189 KEEFER STREET (COMPLETE APPLICATION)
DE415496 - ZONE HA-1A

DEVELOPMENT PERMIT STAFF COMMITTEE MEMBERS

DEVELOPMENT PERMIT STAFF COMMITTEE RECOMMENDATION: APPROVE

Level 3 - Landscape Plan

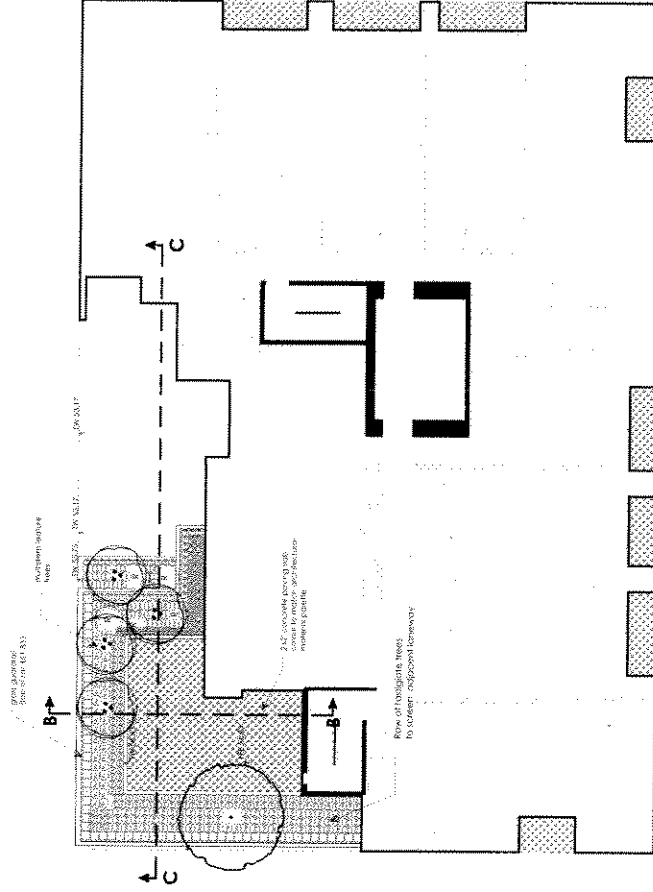
A.1.1 Design development of the small level 2 outdoor deck to improve their specific climate and shadow conditions functionality and place-specific design:

- level 2 deck: reduce trees and / or canopies to maximize sunlight, increase usable paving to support adjacent amenity functions, provide privacy screening to unit, and integrate shade tolerant plant species.
- level 10 deck: incorporate more playful, organic shapes and/or patterns, custom furnishings and play equipment; seriously consider plant species and design themes that reference Asian culture or other characteristics specific to Chinatown and this location;

**Roofdeck
Landscape Plan**

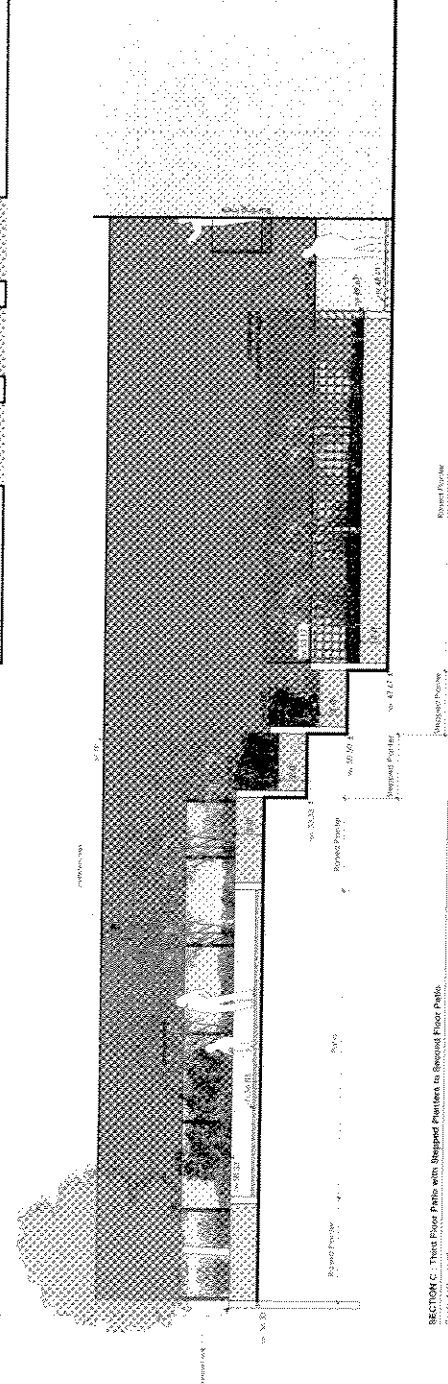
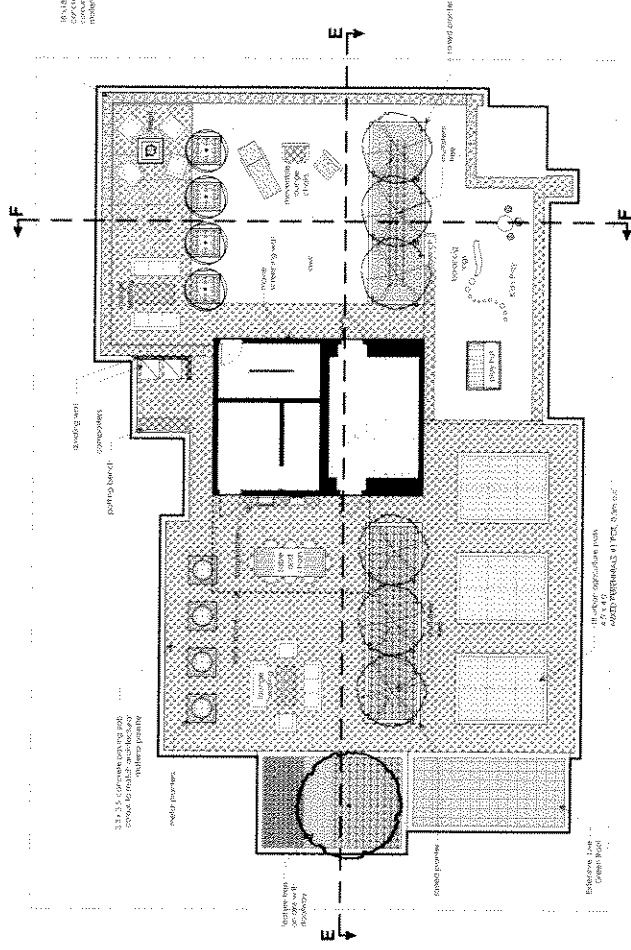
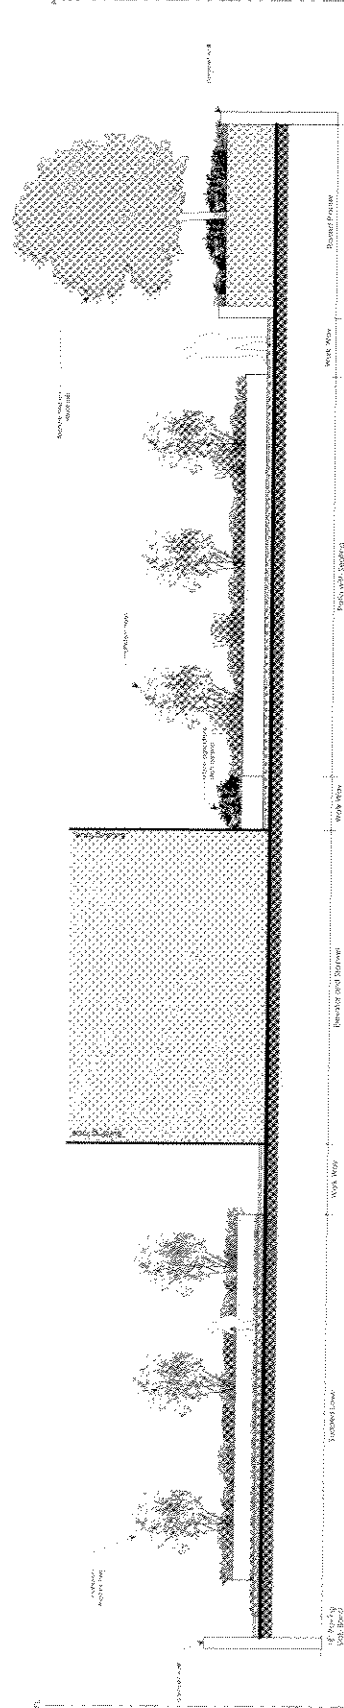
- the three trees from the inner courtyard on Level 1, as the light levels will not be high enough to sustain growth;
 - the roof trellis attached to the mechanical and elevator housing shown on page L4, but not illustrated on the architectural plans; and
-

- the notation of the 'movie screening wall' from the roof terrace plans on page L4 of the Landscape Plan;
